APR. 1988 BX-8/16

SERVICE NOTES First Edition

CHANGE INFORMATION

Change PHONES ground

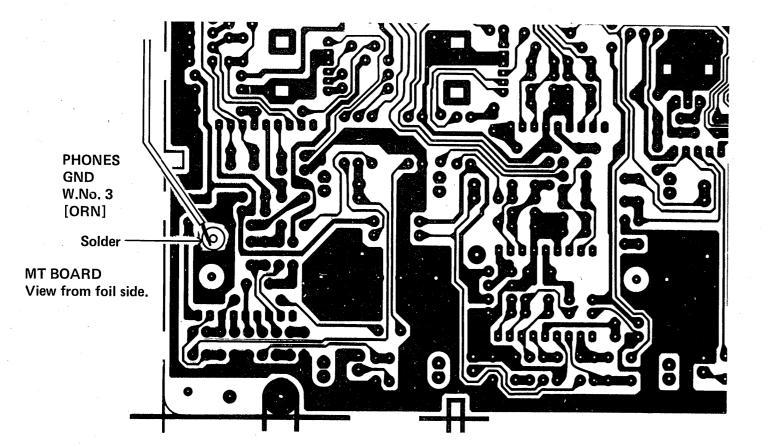
CAUTION: This modification is mandatory . . . Must be conducted on all products as retrofit.

EFF : BX-8 881800-UP

: BX-16 881500-UP Change soldering point of phones return path.

Reason: Eliminate crosstalk.

PHONESグランドライン・ワイヤリング取り付け箇所変更

修理等の際は製造番号を確認し、変更が実施されているかを調べ

て下さい。

実施製番:BX-8 881800

BX-16 881500

理由 :クロストーク改善の為

変更箇所:下図参照
